Access Compliance Report

Public Rights-of-Way

(Curb Ramps)

Intersection ID: 10017771	Main Street: OLD_STATESVILLE_RD	Cross Street: N/A	Location: W
ADA ID: 6B6CFDFE527E	Ramp Type: Perp	Initial Pass/Fail: Fail	Overall Compliance: No
Severity Score: 33.75			
Codes/Mitigation Info/Possible Solution		Field Measurements/Component Compliance

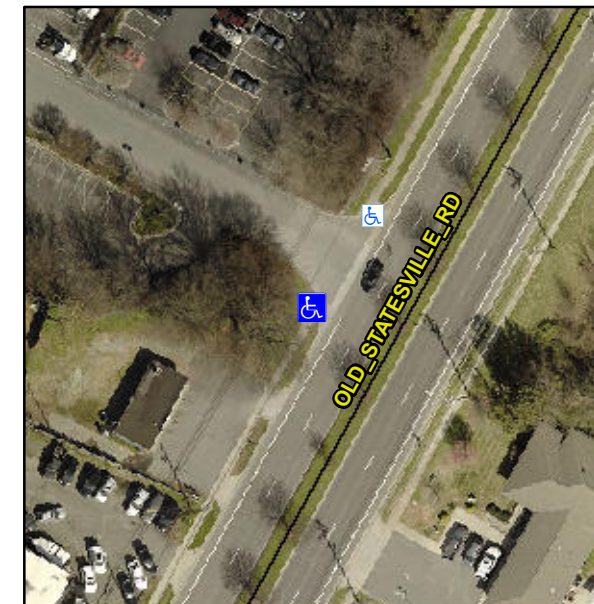
R304.5.1, R304.2.2

Compliance	Description	Data	Compliance	Description	Data
N/A	Ramp Length (in)	44.0	No	Ramp Slope (%)	15.3
No	Ramp Width (in)	37.5	Yes	Ramp XSlope (%)	0.8
N/A	Flare Type LT	N/A	N/A	Flare Type RT	N/A
N/A	Flare Slope LT (%)	N/A	N/A	Flare Slope RT (%)	N/A
N/A	Flare Traversable LT?	N/A	N/A	Flare Traversable RT?	N/A
N/A	Landing Length (in)	N/A	N/A	DWS Provided?	N/A
N/A	Landing Width (in)	N/A	N/A	DWS Contrast?	N/A
N/A	Landing Slope (%)	N/A	N/A	DWS Length (in)	N/A
N/A	Landing X Slope (%)	N/A	N/A	DWS Full Width?	N/A
N/A	Landing Curb? (Y/N)	N/A	N/A	DWS Offset (in)	N/A
N/A	Shared Landing?	N/A			
N/A	Gutter Ponding?	N/A	N/A	Gutter Slope (%)	N/A
N/A	Gutter Lip Ht (in)	N/A	N/A	Gutter X Slope (%)	N/A
N/A	Painted X Walk1?	No	N/A	Painted X Walk2?	N/A
	X Walk 1 Direction	To N		X Walk 2 Direction	N/A
N/A	X Walk 1 Width (in)	N/A	N/A	X Walk 2 Width (in)	N/A
	X Walk 1 Slope (%)	0.6		X Walk 2 Slope (%)	N/A
	X Walk 1 X Slope (%)	5.2		X Walk 2 X Slope (%)	N/A

Remove & Replace Entire Ramp.
